**LEXINGTON-FAYETTE URBAN COUNTY
 GOVERNMENT CONTRACT CHANGE ORDER**
 Page 1 of 2

Date:	July 3, 2019	
Project:	Town Branch Thickening Process Upgrades	
Location:	Town Branch WWTP	
To (Contactor): Dugan & Meyers, LLC 11110 Kenwood Road Cincinnati, OH 45242	Contract No.	305-2018
	Original Contract Amt.	\$3,222,000.00
	Cumulative Amount of Previous Change Orders	\$0.00
	Percent Change - Previous Change Orders	0.00%
	Total Contract Amount Prior to this Change Order	\$3,222,000.00
	Change Order No.	1

JUSTIFICATION FOR CHANGE

PROJECT: Town Branch Thickening Process Upgrades

Photo #1

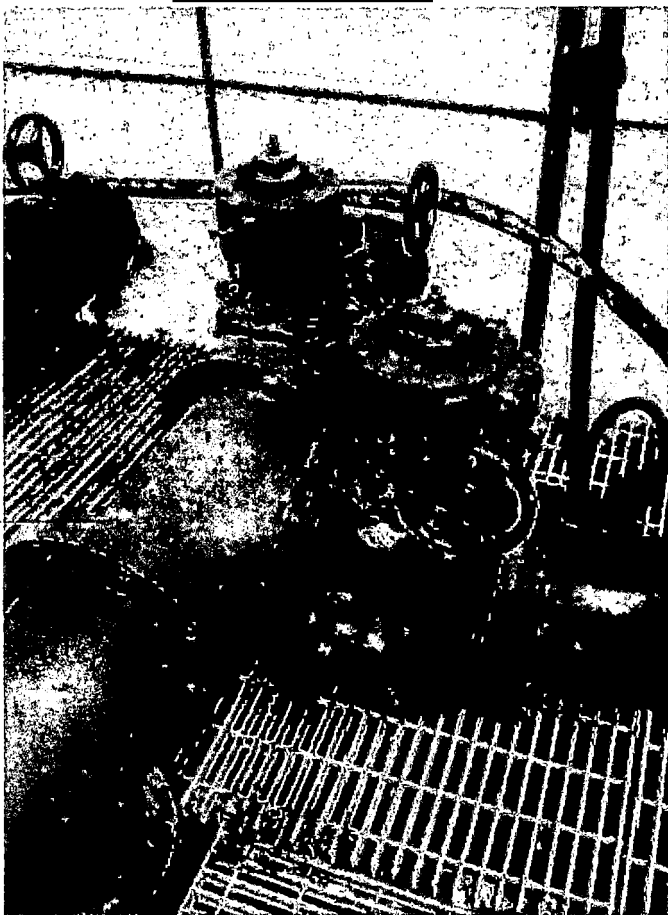
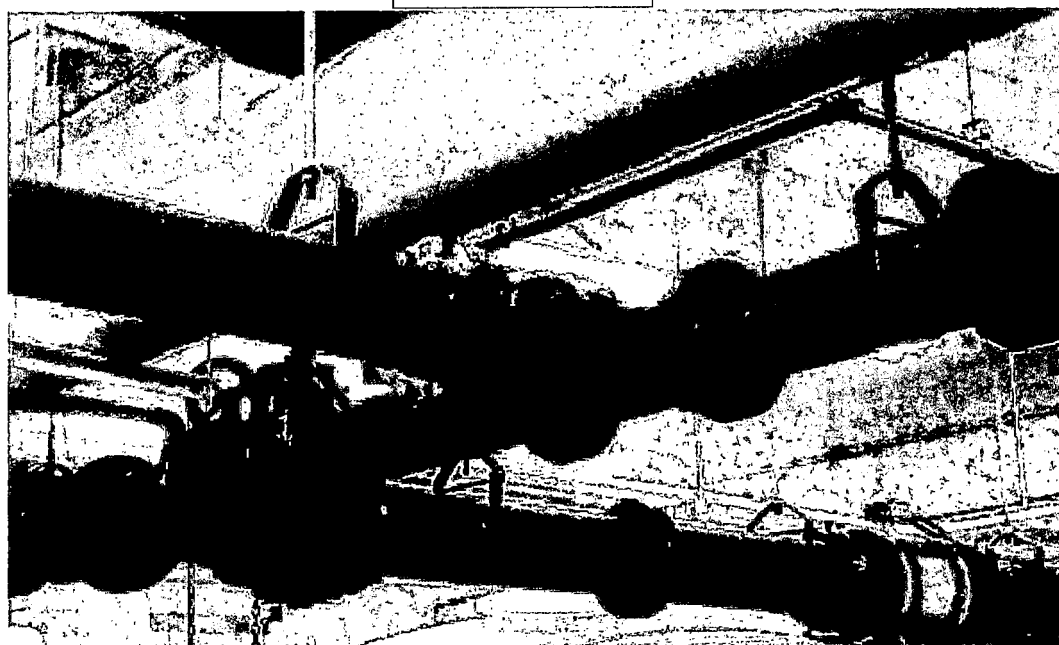
Section 4 on sheet M-03-301 indicates that the filtrate line coming out of the distribution box is a 10" line. Based on this section cut D&M became concerned regarding the size of two (2) valves in the Gravity Thickener Building which tie to this line but are labeled 8". During our 2/20/19 site visit D&M field measured the valves in place and confirmed that they are 8" valves as scheduled, however we noticed a few discrepancies from the drawings of which we were not previously aware, see attached markup of sheet M-03-101 and photos.

1. The valves in section 4 on M-03-301 are 8".
2. There are 21 6" plug valves to be replaced in the Gravity Thickener Building. The attached drawing is correct.
3. There are 6 8" plug valves to be replaced in the Gravity Thickener Building. The attached drawing is correct.
4. Regarding the concern that the centerline of the pipe will be affected by replacement of the eccentric reducers at the tee in the Gravity Thickener Building, D&M previously requested a different piping arrangement at the tee which should align with the existing pipe. D&M requested to install a 8x8" true wye with reducers as opposed to the 8x6" reducing true wye called out in the plans. Use eccentric reducers to match the existing centerline.

JOB NAME:	Town Branch WWIP Thickening Proces	EQUIPMENT DESIGNATION:	MCC-E2
JOB LOCATION:	421	EQUIPMENT TYPE:	MODEL 6 MOTOR CONTROL CENTER
DRAWN BY:	(Q2C)	DRAWING TYPE:	ELEVATION
ENGR:			
DATE:	May 21 2019		
DRAWING STATUS:	QUOTE

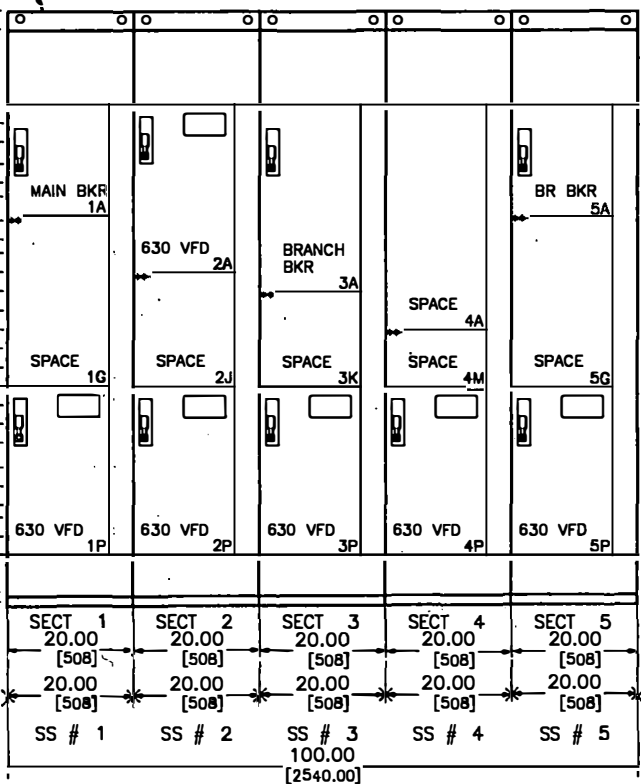
Description: C.O. #2 - Field Order #2 - Pricing includes TEM Group, Inc. furnishing and installing additional conduits, fittings, supports and wiring required for additional feeder conduits from existing MCC's to the two new MCC's per revised drawing E-00-603. Also included in pricing are the additional cost for revised Square D Motor Control Centers and two additional 200Amp Feeder Breakers added to the existing Eaton Motor Control Centers per the revised Field Order #2 Drawings dated 04/25/19.

**GRAVITY THICKENERS TANK PLAN & SECTION
 NEW EQUIPMENT**
 TOWN BRANCH WWTP THICKENING PROCESS UPGRADES
 LEXINGTON-FAYETTE URBAN COUNTY GOVERNMENT

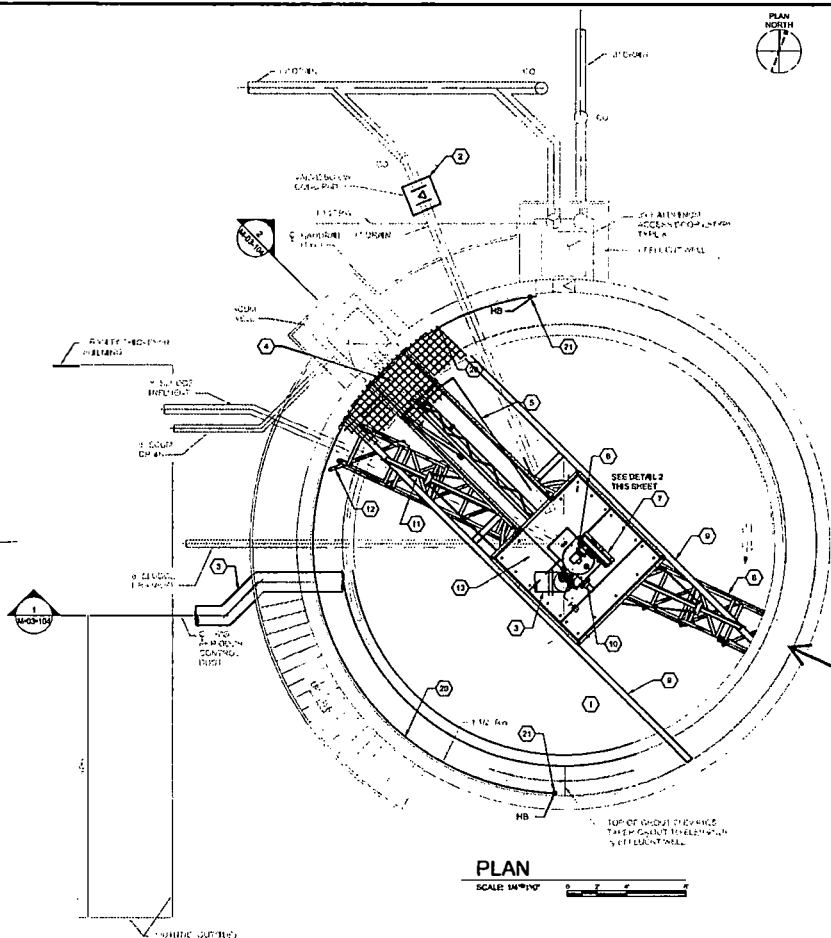
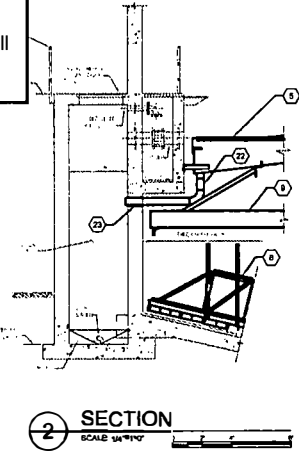
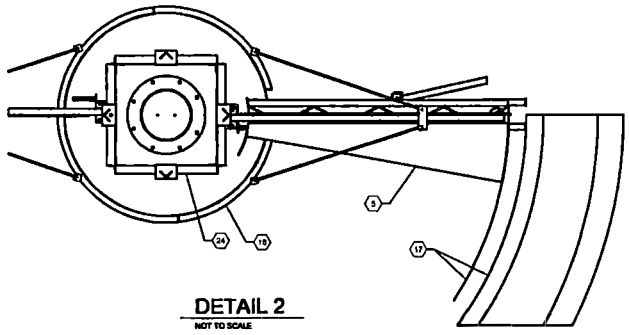
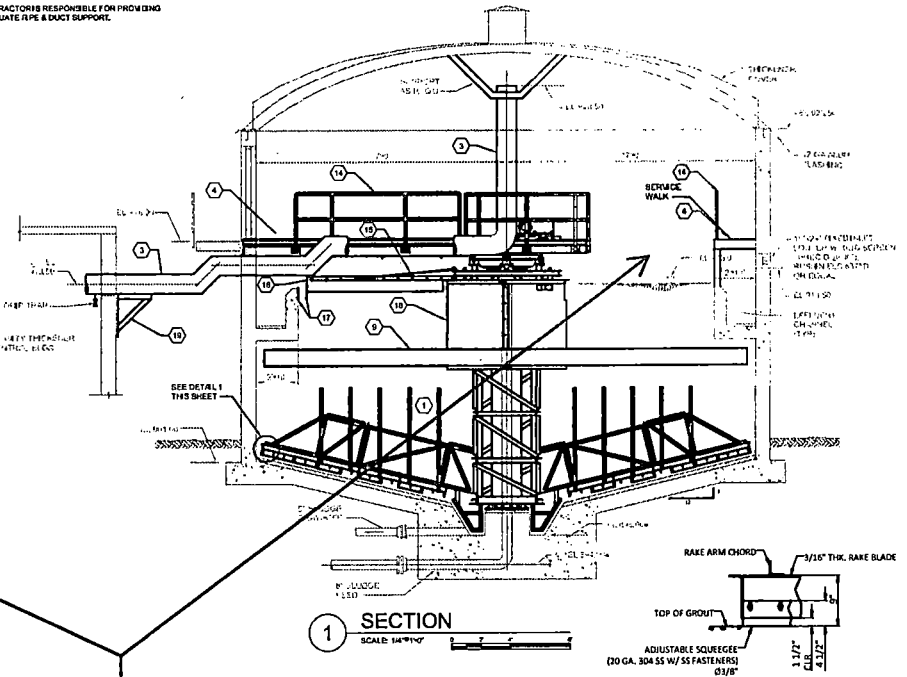
In follow up to onsite discussions with LFUCG on 5/2/19, Dugan & Meyers proposes to remove the handrail & grating at the (2) two Thickener Tanks from the scope-of-work for the lump sum credit amount of <\$25,100.00>.

Existing Handrail and Grating to Remain. Both Tanks.
 New Handrail and Grating will be provided on the new Vendor furnished bridge.
